Our Ref: P-19107

RE: WRITTEN STATEMENT TO SUPPORT AN S4.55(1A) MODIFICATION APPLICATION TO VARY PROJECT APPROVAL MP11_0093 FOR DEVELOPMENT OF THE PEMULWUY PROJECT, REDFERN

This application seeks to modify condition B21 and Statement of Commitments item no. 16 within development consent MP11_0093 MOD1. Further detail in relation to the extent of the modifications is provided in **Section 2.2**.

Typical NAU Apartment Plan

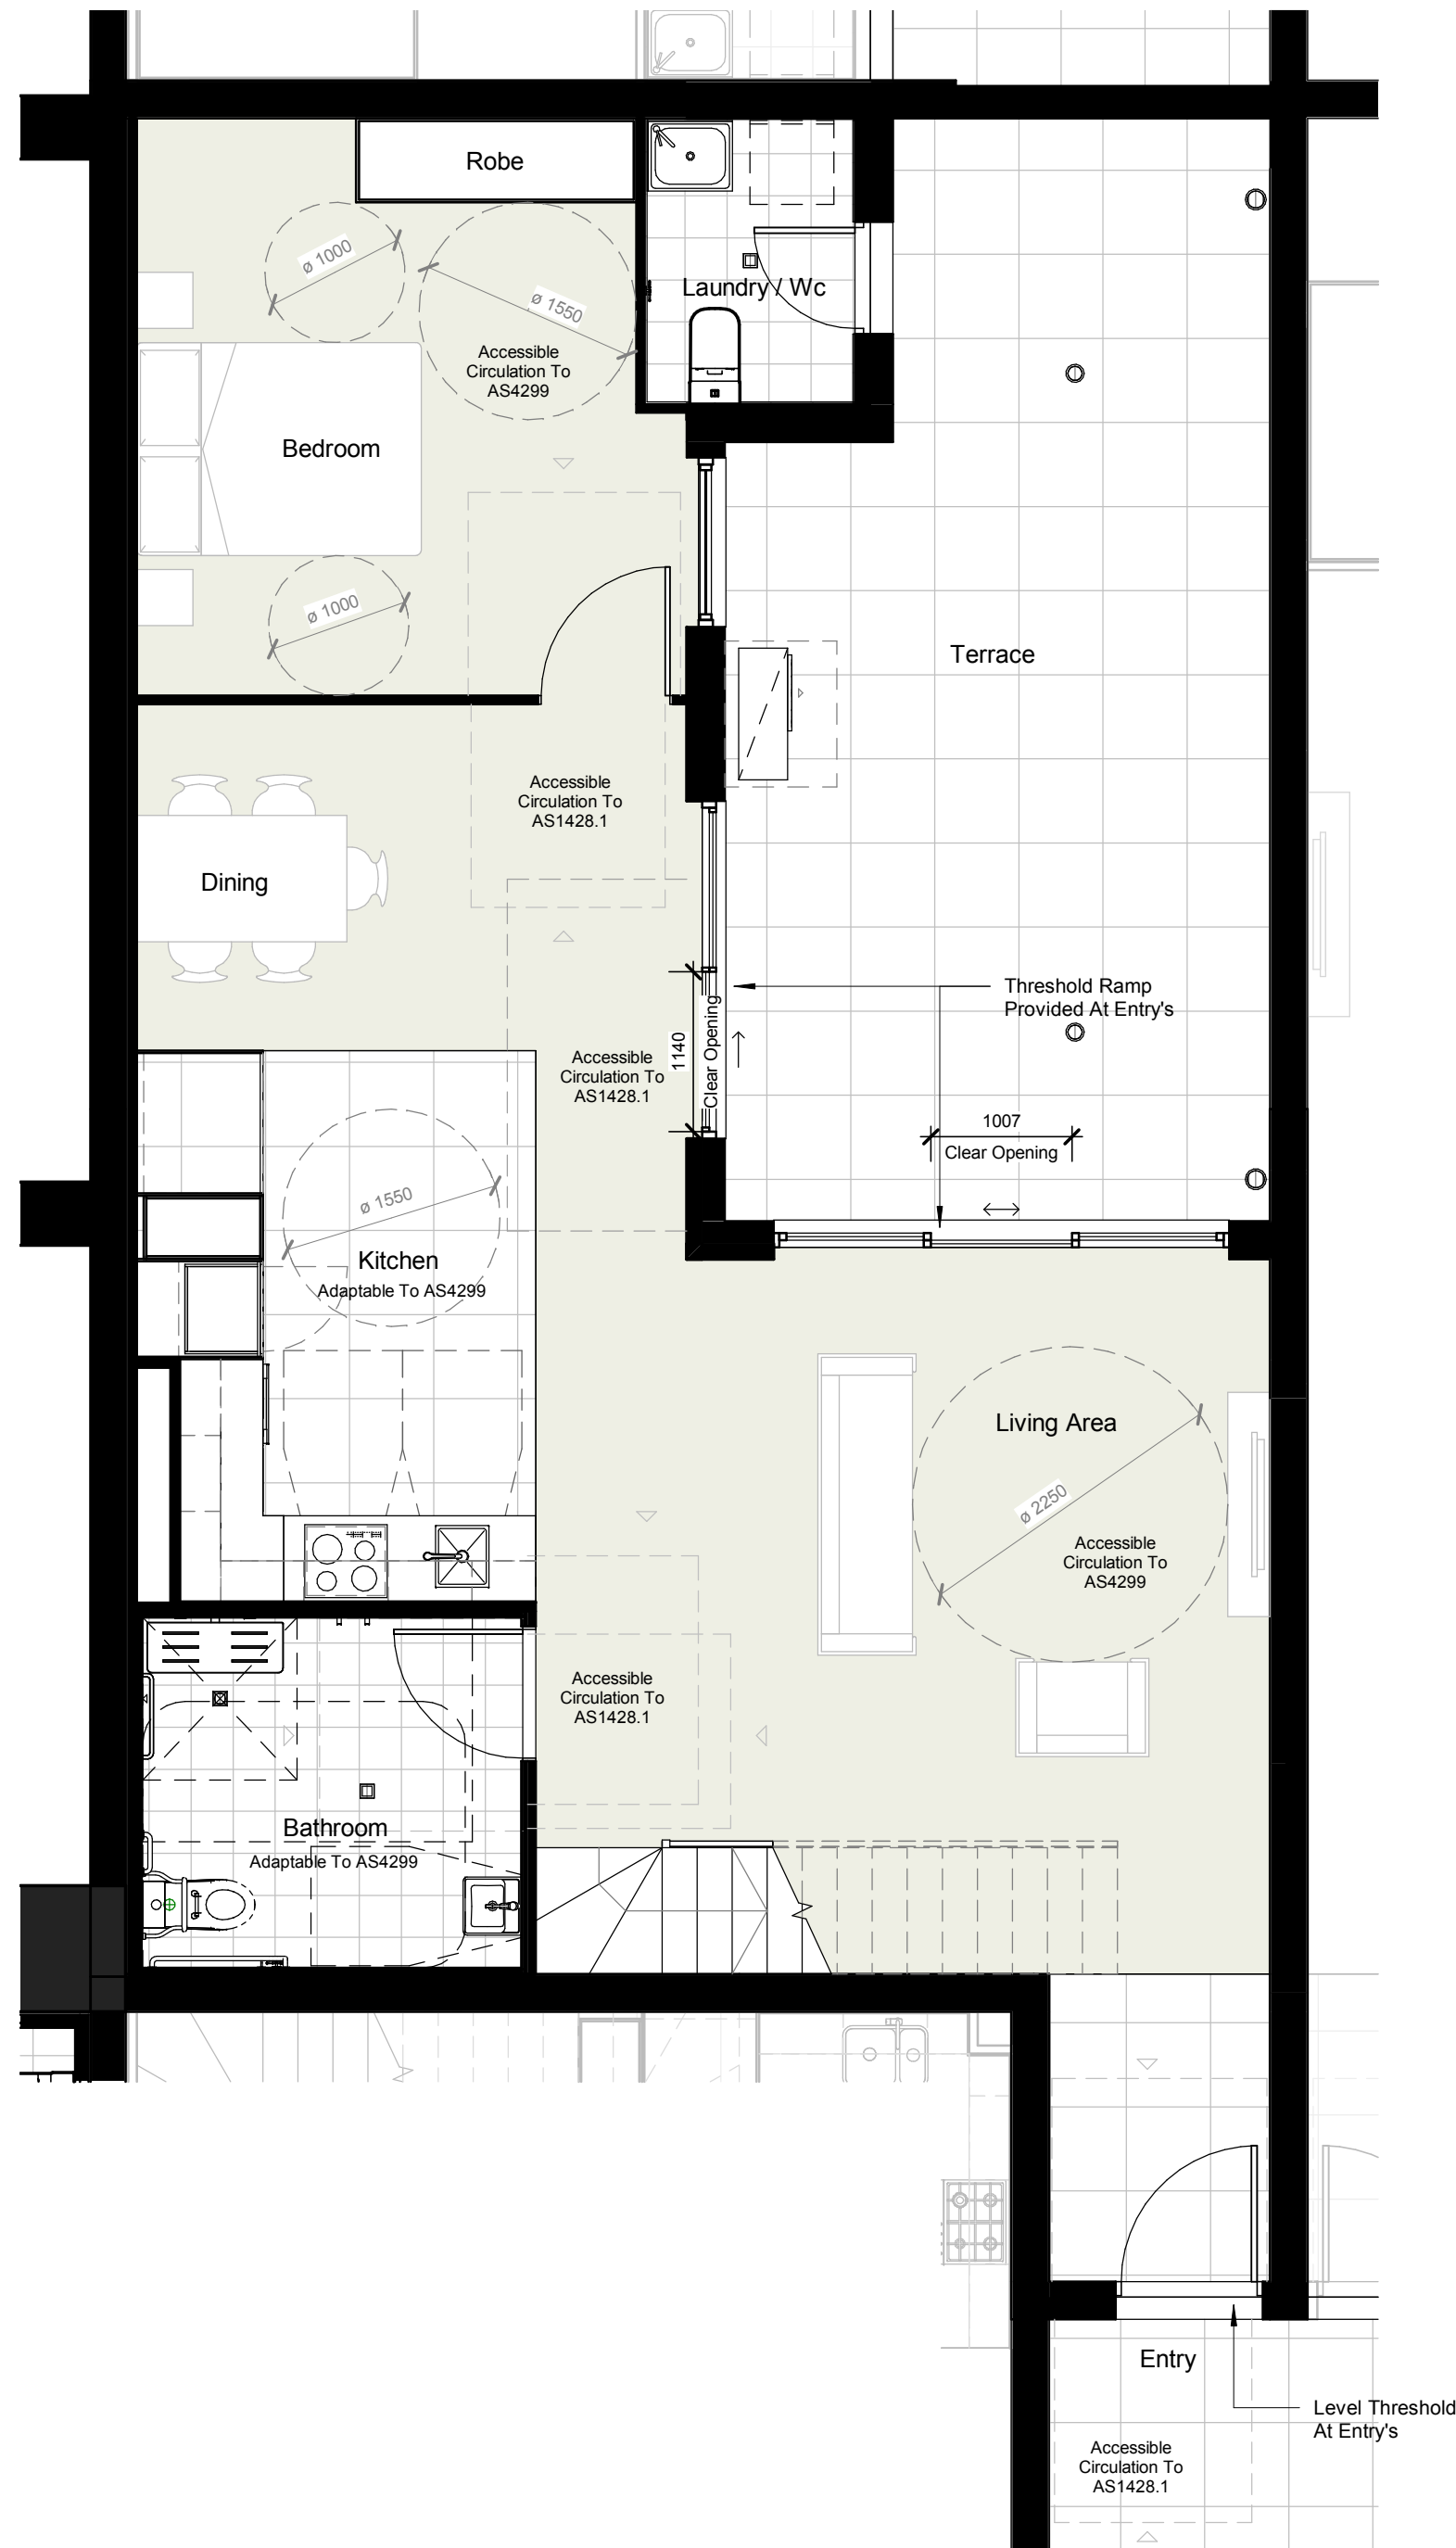
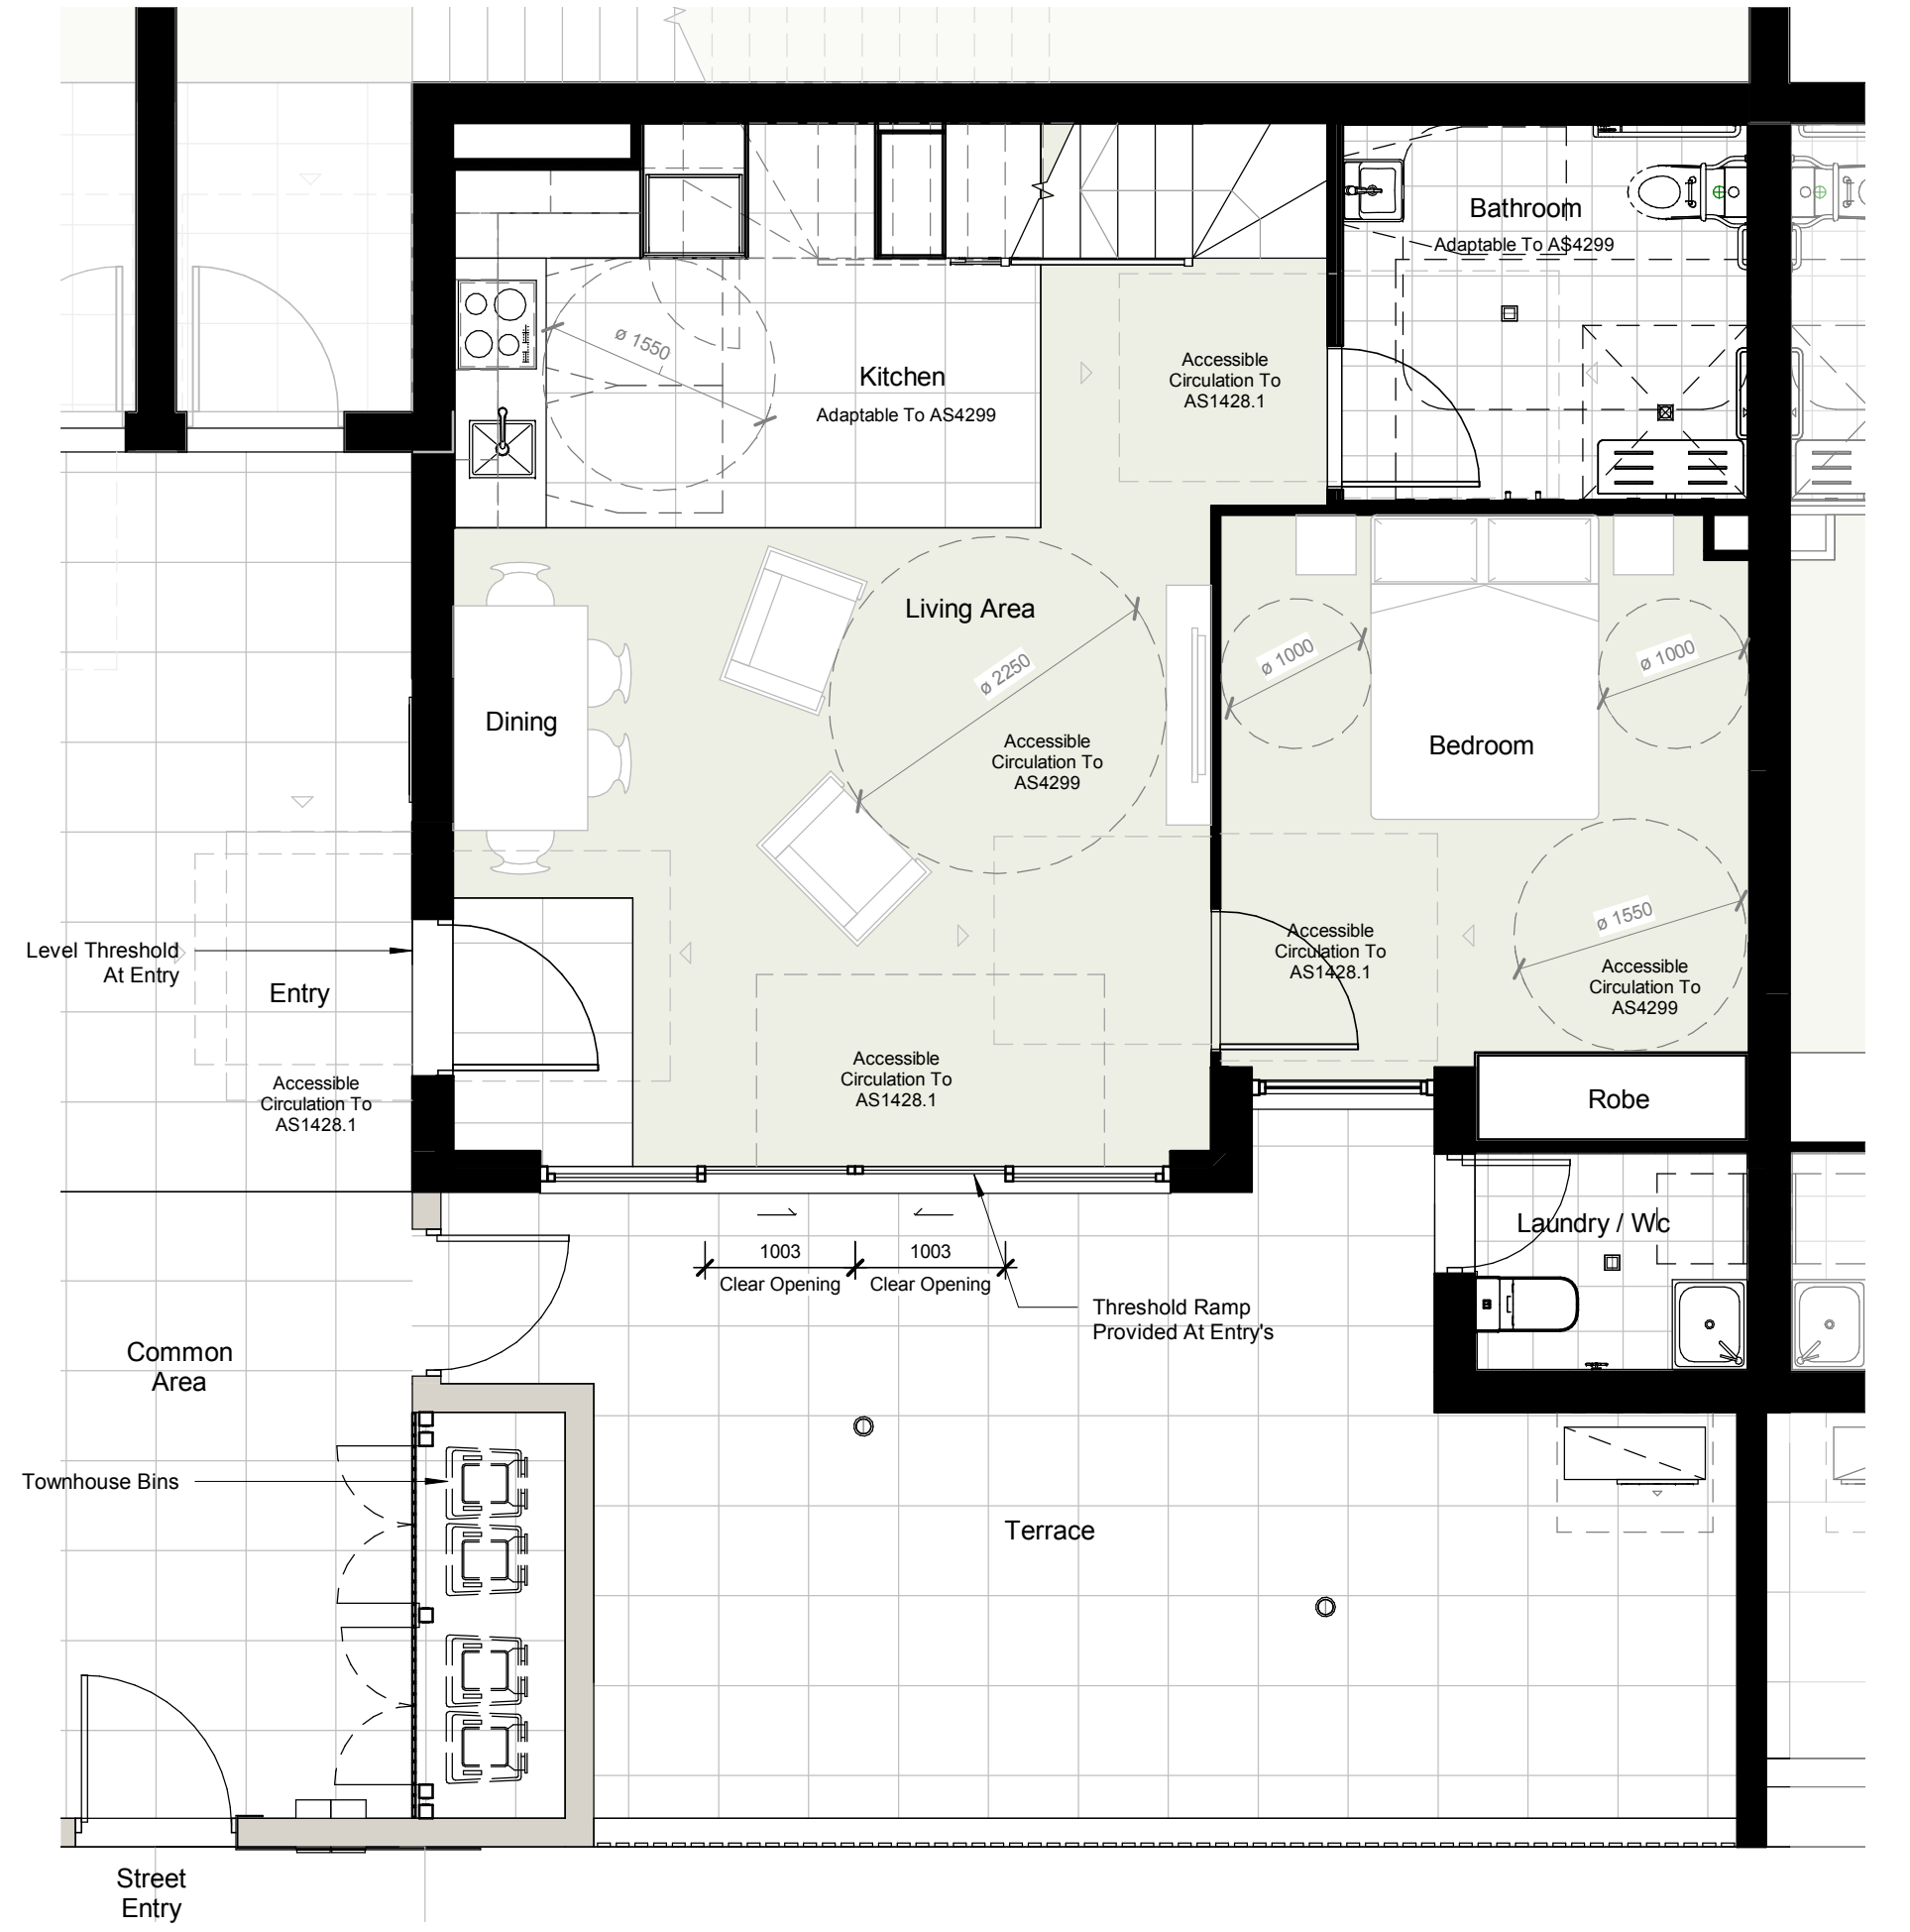
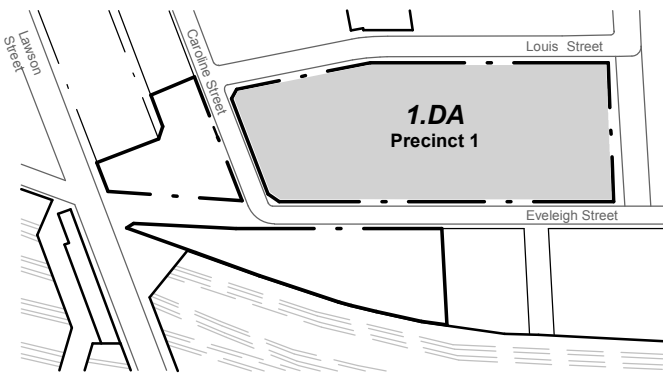
1 : 50 NAU Apartments 44 , 50, 56 & 62

1 : 50 Townhouse No's 08, 11, 12, 15, 16, 22, 24, 25, 28, 29, 32 & 33
